## Design Review Board

March 22, 2017

<b>NAME OF PROJECT:</b>	
Spokane Falls Combined Sewer Overflow (CSO 26) Control Facility - PLAZA	
<b>ADDRESS:</b>	
218 N. Monroe Street	
<b>TYPE OF PROJECT:</b>	
<input checked="" type="checkbox"/> Public Project <input type="checkbox"/> Shoreline Conditional Use Permit <input type="checkbox"/> Skywalk Over Public ROW	<input type="checkbox"/> Required by CBD Zones and Downtown Plan <input type="checkbox"/> Design Departure
<b>FEES:</b>	
Standard Board Review Paid for by Interfund Charge - Utilities	
<input type="checkbox"/> \$1275 (up to 3 meetings)	<input type="checkbox"/> \$500 per additional meeting if necessary

1 NORTH WALL ELEVATION

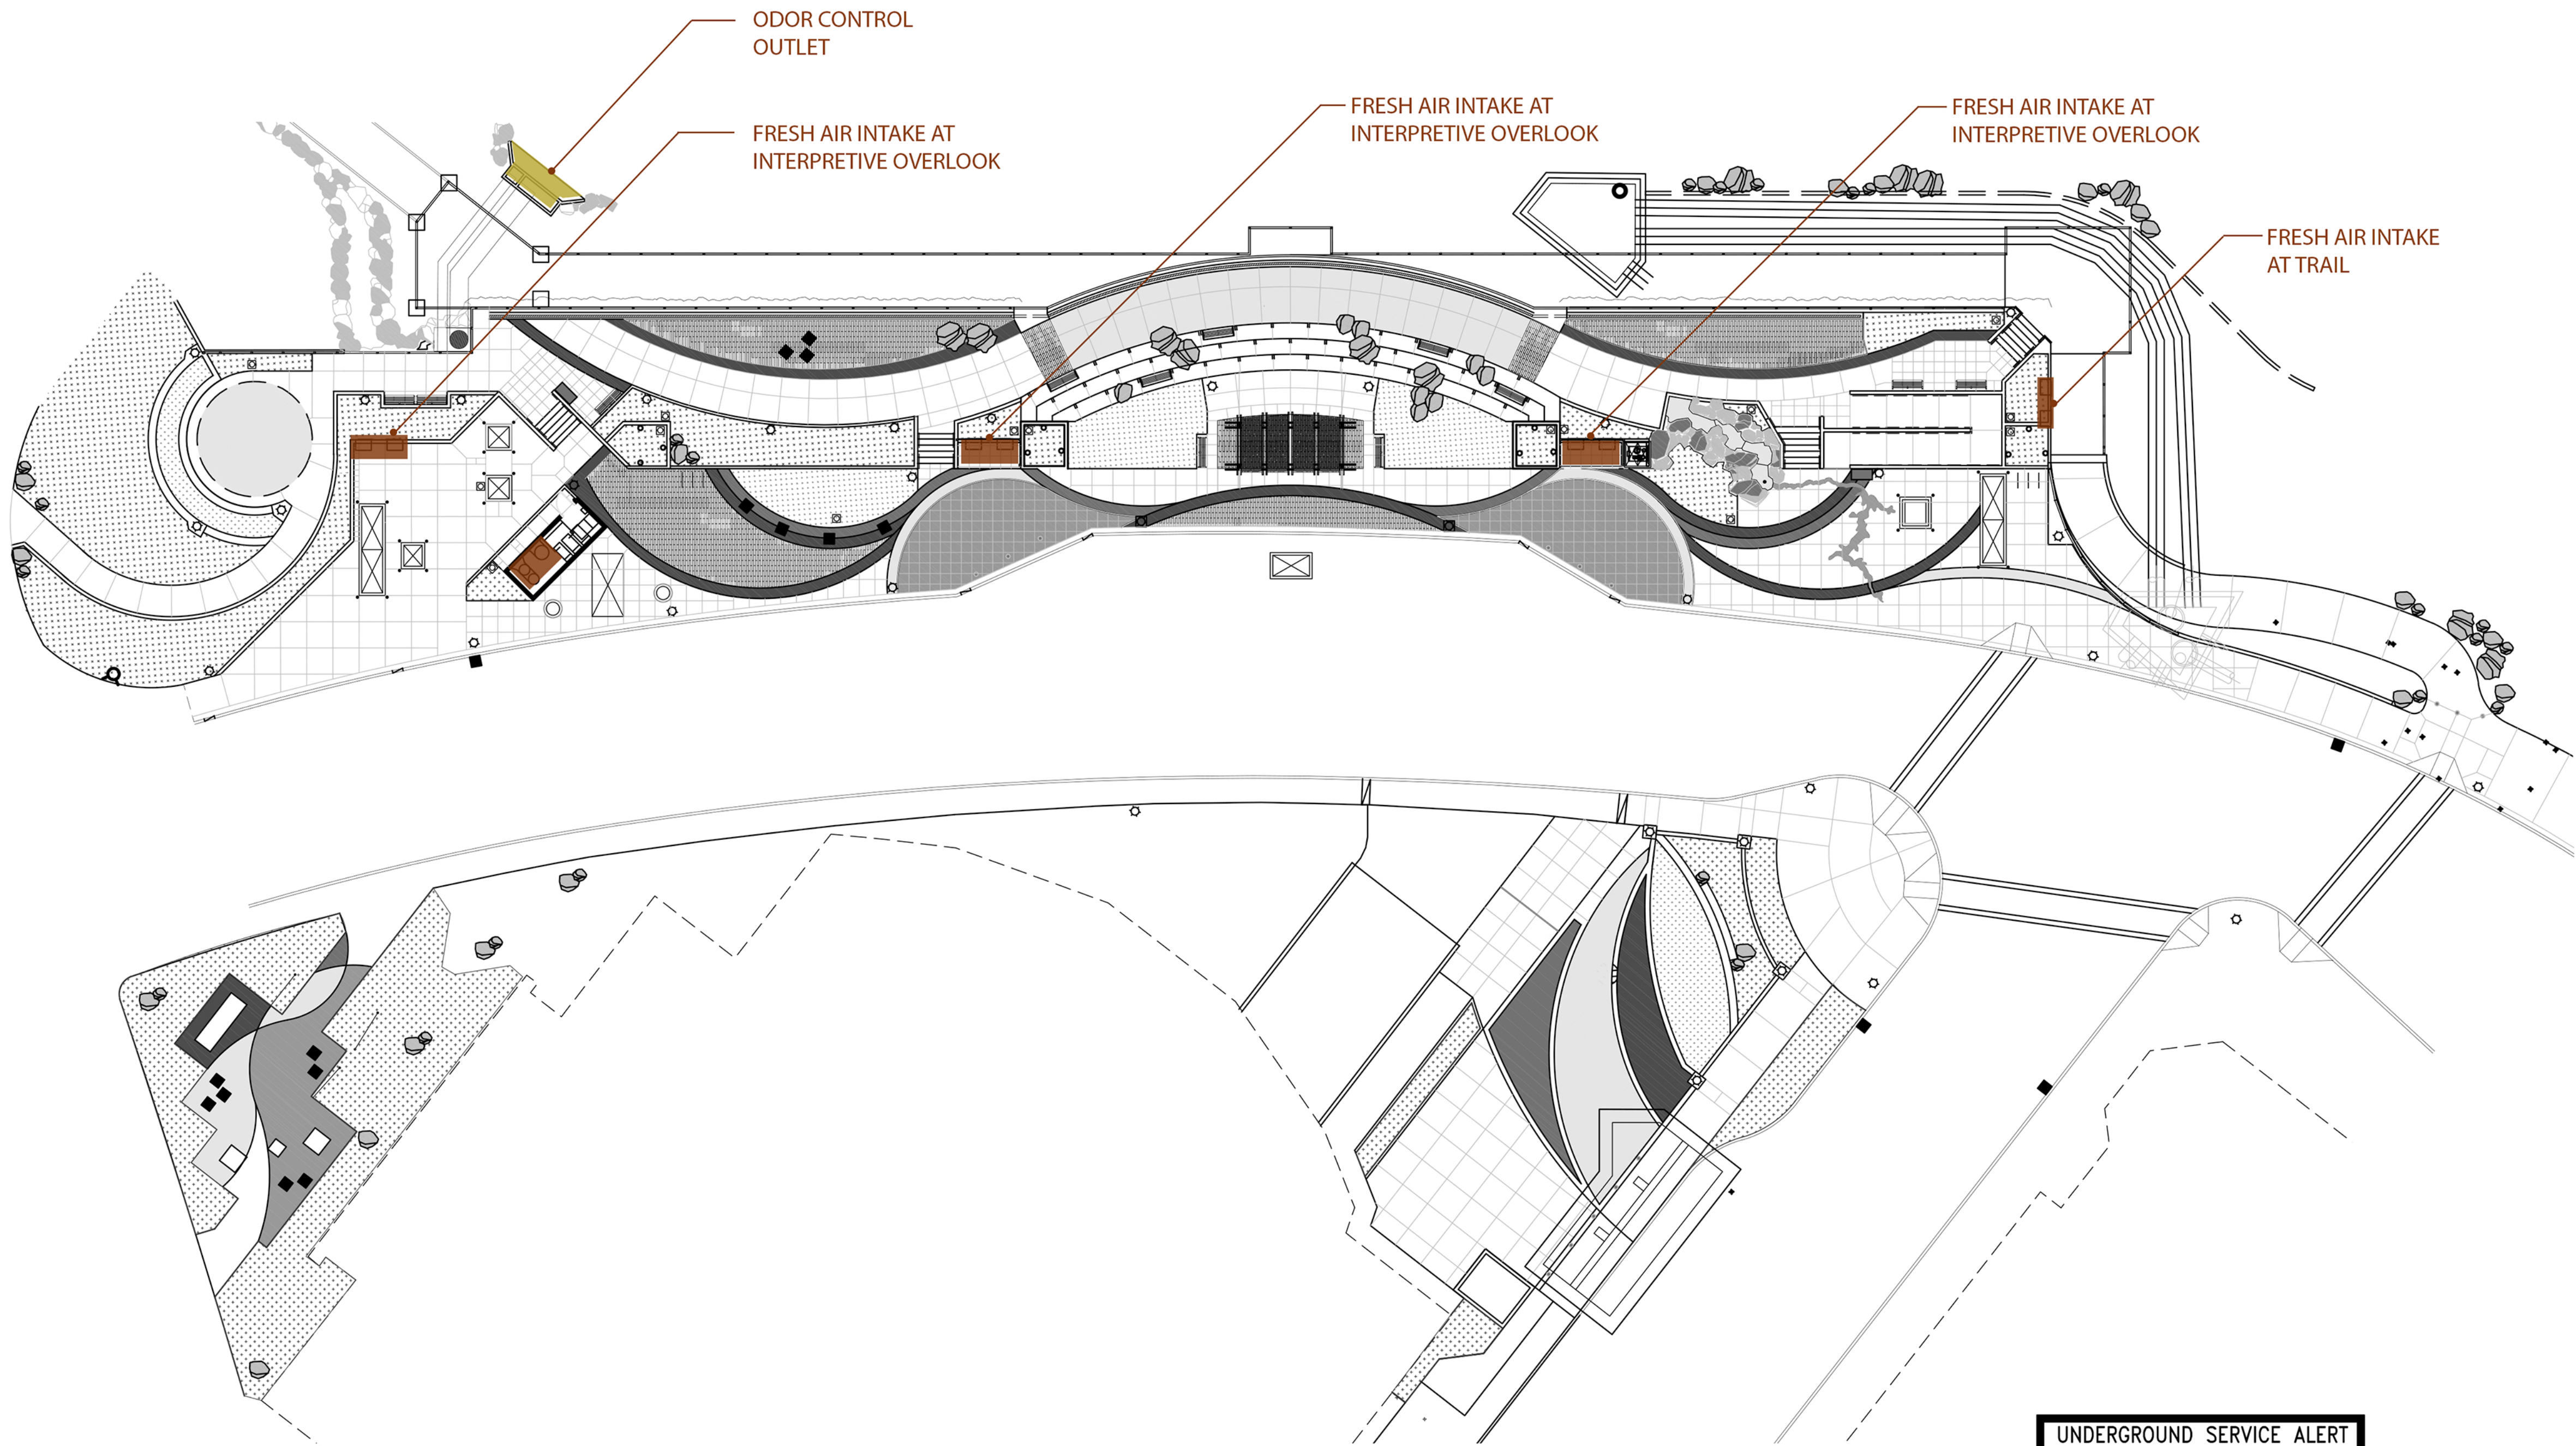
1. Applicant shall consider further articulation of the north wall to better incorporate man-made structures with the natural landscaping, mitigating the bulk of the tank, and elevating the design quality of the multi-use pathway to same degree as the plaza.
2. Applicant shall consider odor control and the location of exhaust venting.
3. Applicant shall consider opportunities within the design and budget to provide pedestrian connection directly to the lower Huntington Park.
4. Applicant shall consider engaging artists, as early as possible, for visioning and creation of artistic components within this project.
5. Applicant shall consider the priority of a retail space on the site in lieu of expanding the plaza.

- Response: See Attachment #2, North Elevation Character, for current design articulation for the north wall of the CSO tank. Exposed tank walls are currently planned to be constructed with a formliner texture for the entirety. The texture planned for the north tank wall is a 2" basalt relief pattern. In addition to the formliner texture, faux ballast rock carvings are intended for installation along the north bank to soften and naturalize the appearance of the tank structure. Faux basalt carvings shall be similar to those shown in adjacent images (Exhibits #1 and #2). Trellis structures previously shown along the north wall of the tank have been removed. There has been some concern that people could climb such structures. The trail and plaza guardrail design has developed into a decorative railing with wave pattern, similar to the ones found at the Gathering Place near City Hall. See Attachment #3, East Section/Elevation Character for additional articulation and massing imagery. Native plantings have been included at the base of the tank structure and at the east end of the design. Ornamental plantings have been included at the west end of the design and atop the plaza. A current layout of plantings at the base of the tank can be found on draft planting plans, Attachment #6.

City proposed mid-block crossing – Option 3

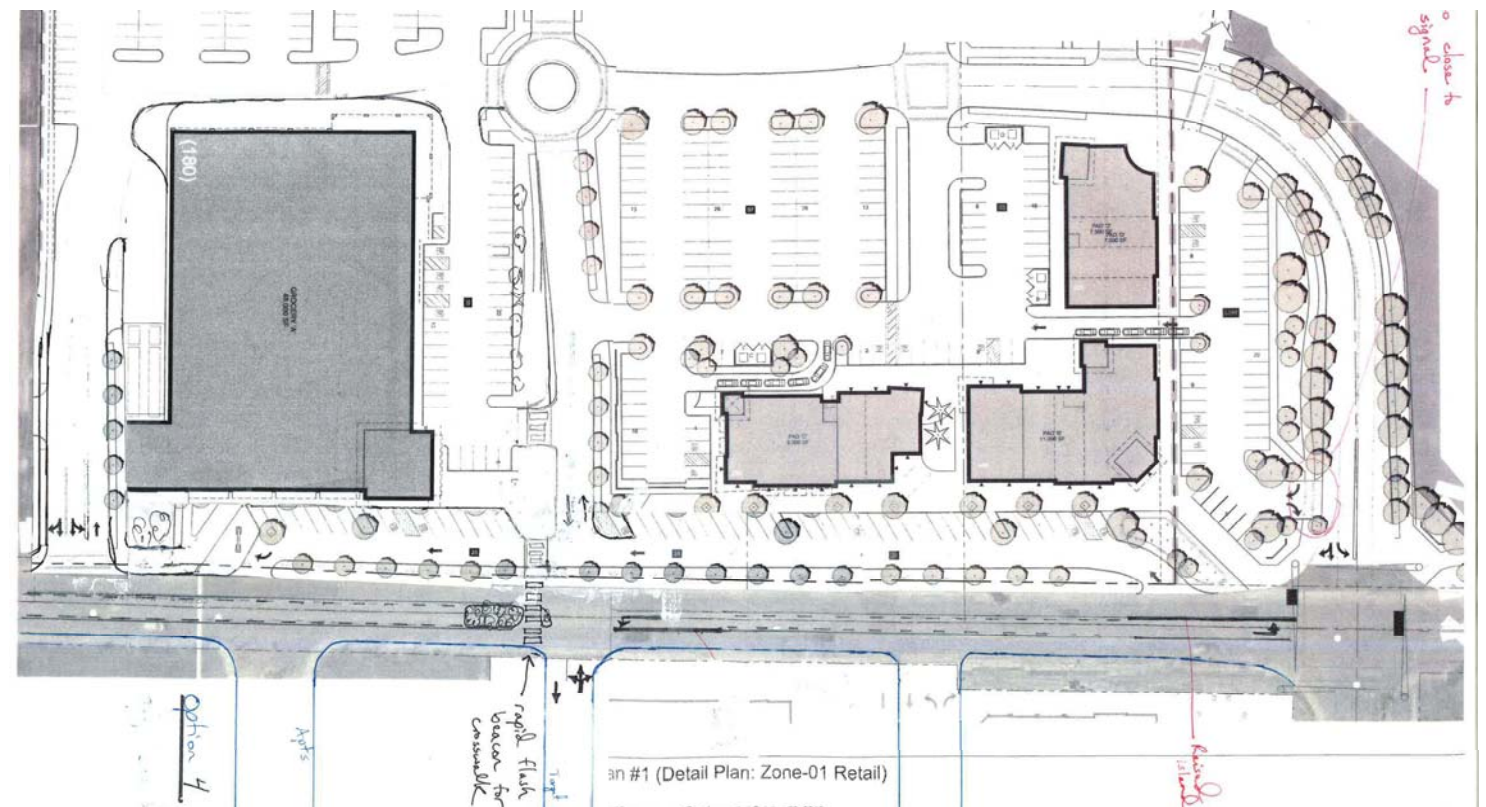
DRB Guidance: *“Applicant to pursue a mid-block, enhanced pedestrian crossing that strives to align with the proposed grid across Regal south of the Palouse Highway intersection in order for the proposal to evolve into an urban district per Section 5.6 of the Development Agreement.”*

A conceptual detail showing the potential Regal St. mid-block pedestrian crossing is shown on Page 06 .

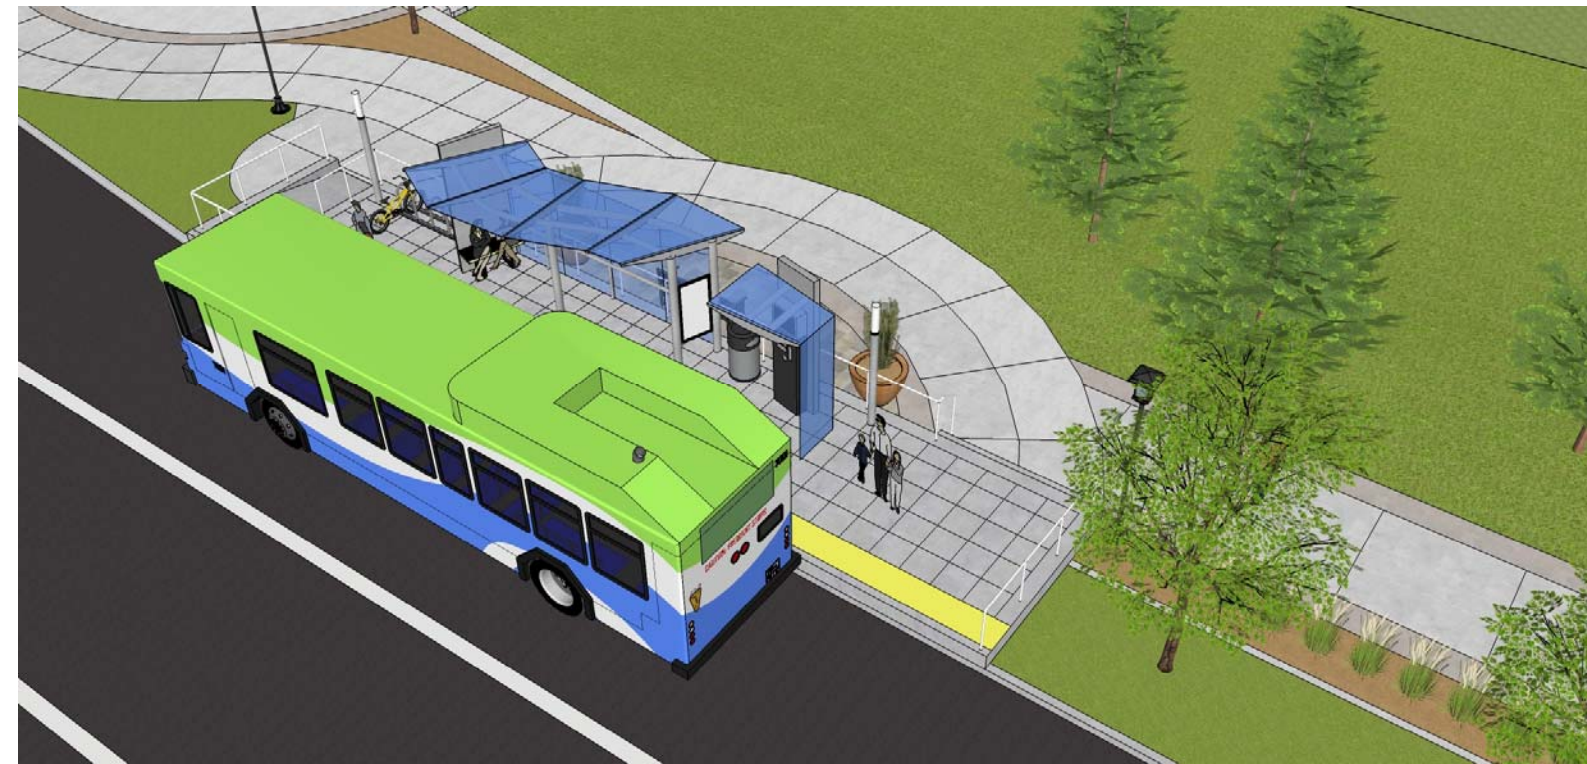
DRB Guidance: *“Work with STA to determine how to best incorporate the future High Performance Transit stop into the development.”*

The development team met with representatives from the Spokane Transit Authority to discuss integrating a future HPT stop into the project. Several locations were discussed. In the end it was decided that a location nearest the northwest corner of the Regal and Palouse intersection would centrally service both the shopping center and sports complex in addition to offering the most direct, convenient and safest access to the crossing of the controlled intersection.

Site: Trees

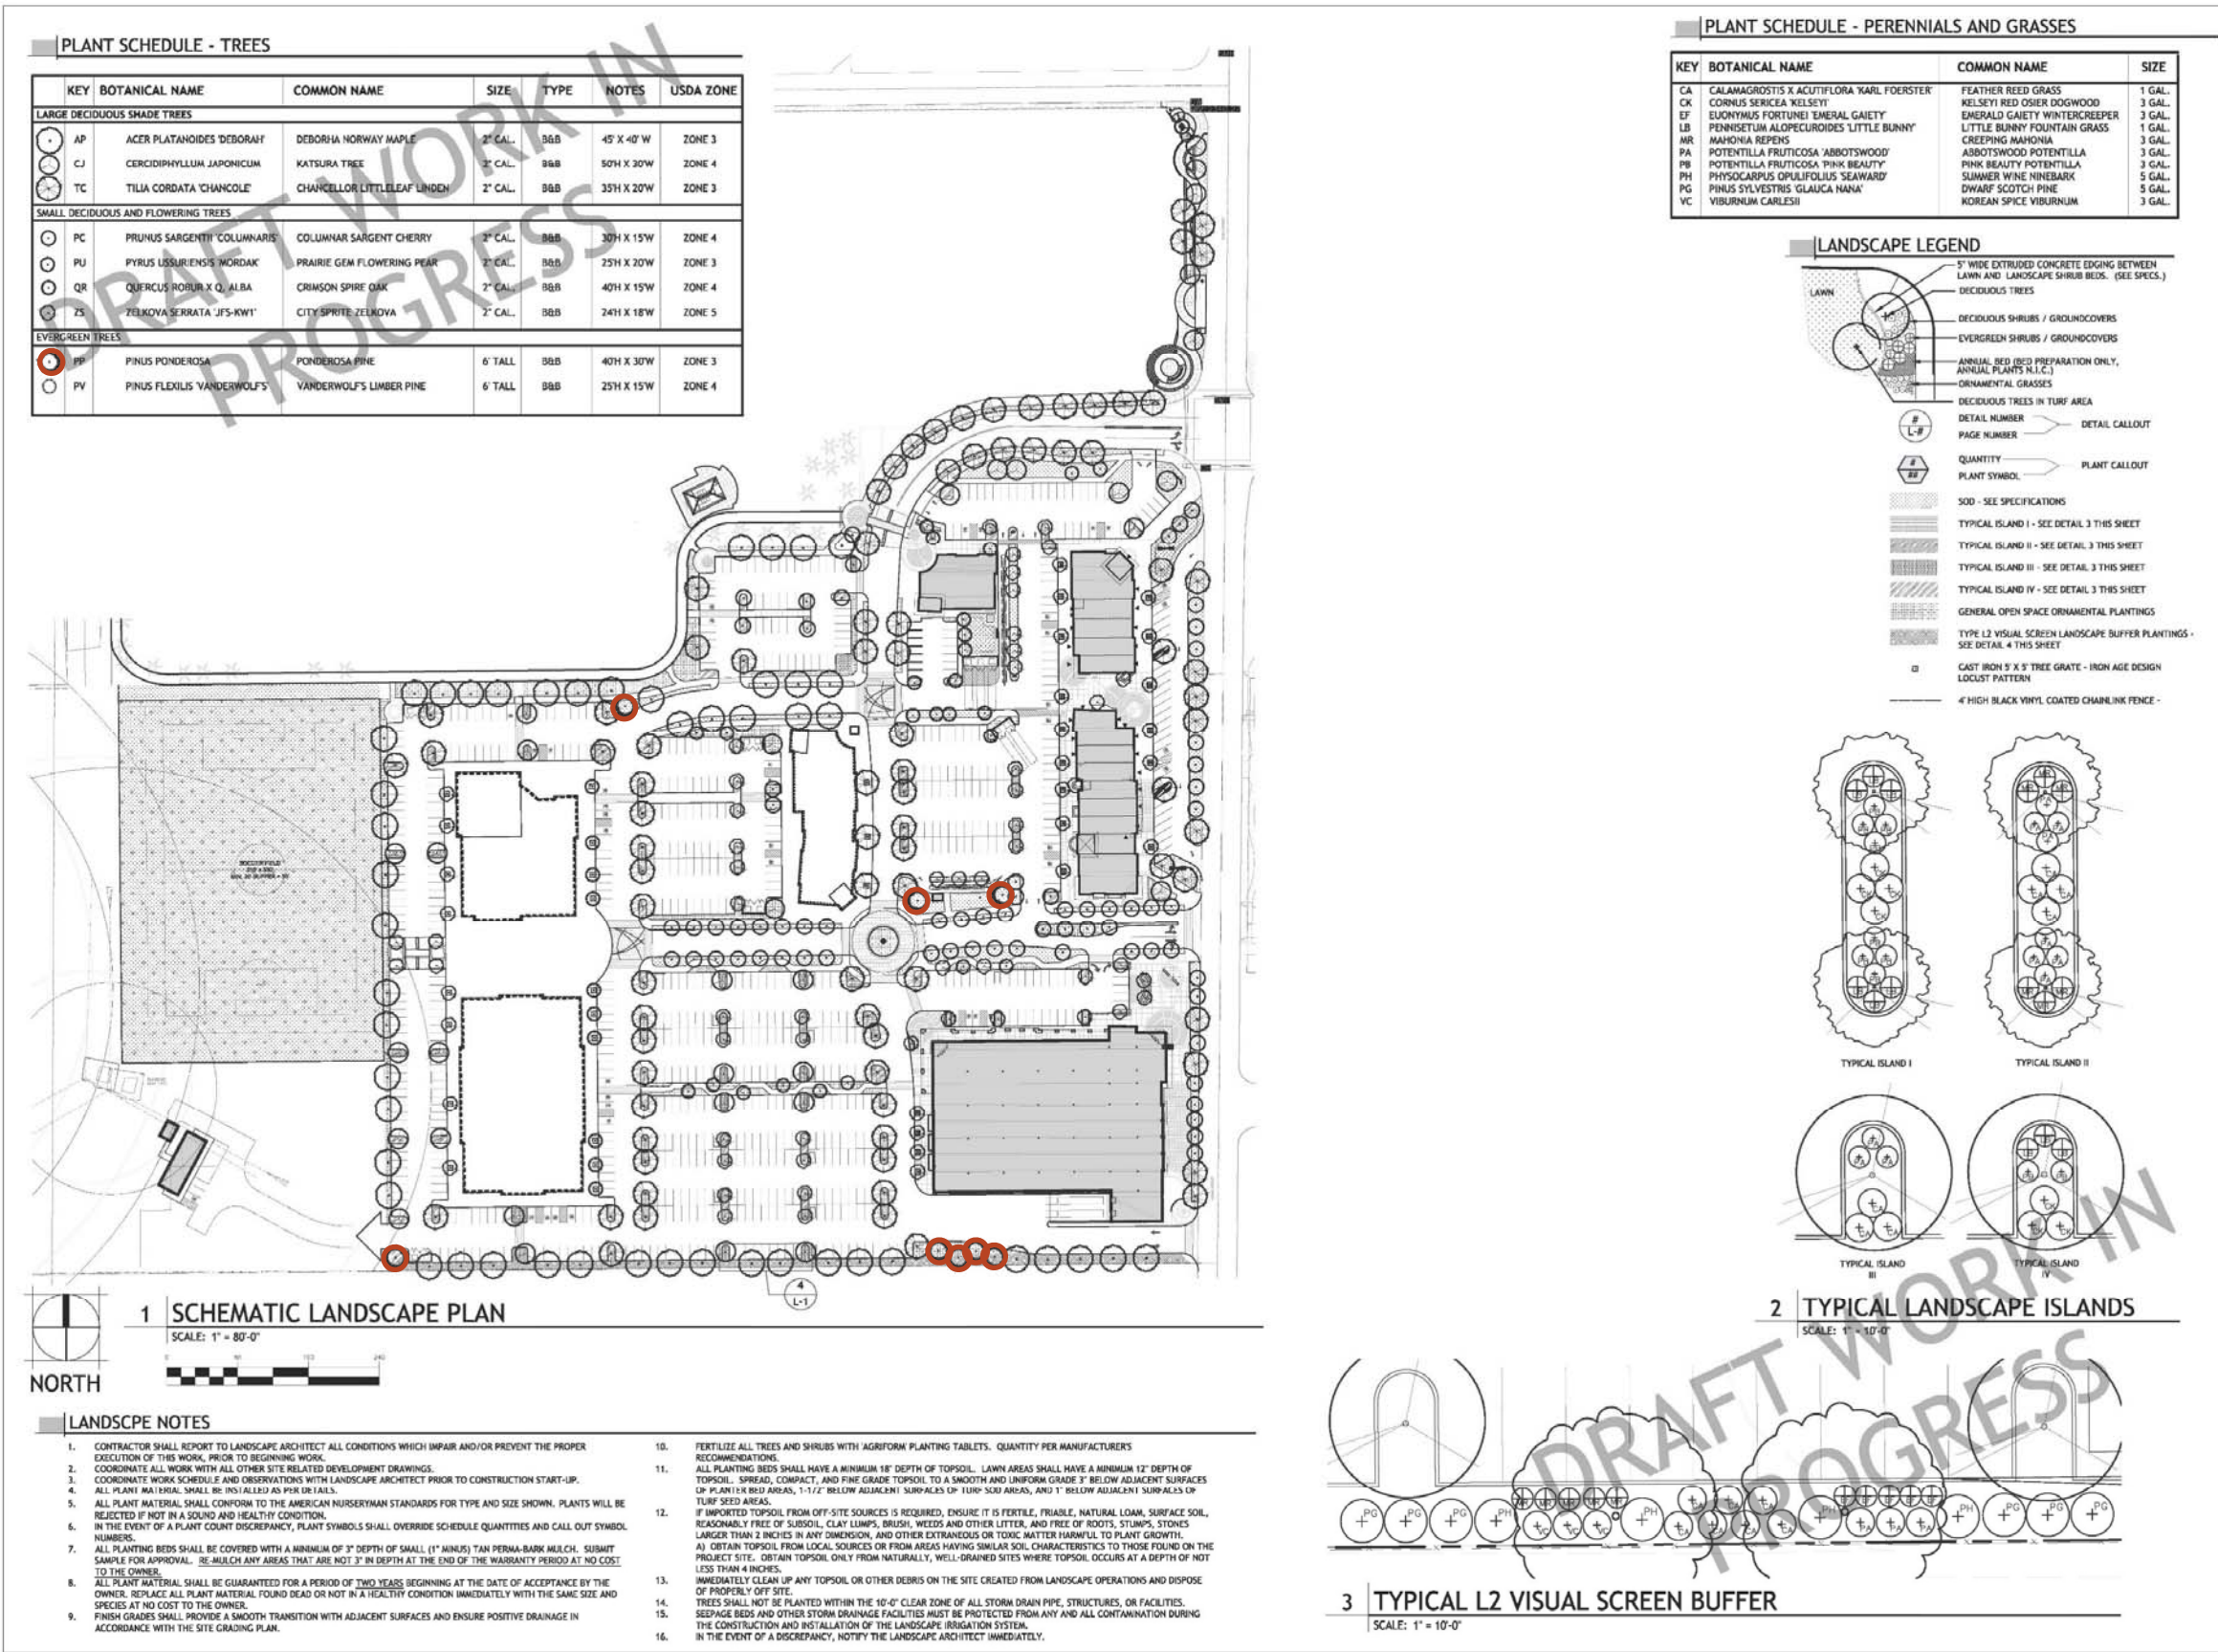
DRB Guidance: “The applicant shall look into opportunities to provide either additional site trees and/or provide select trees of greater size in lieu of saving the two existing ponderosa pines which are in poor health and may be difficult to save.”
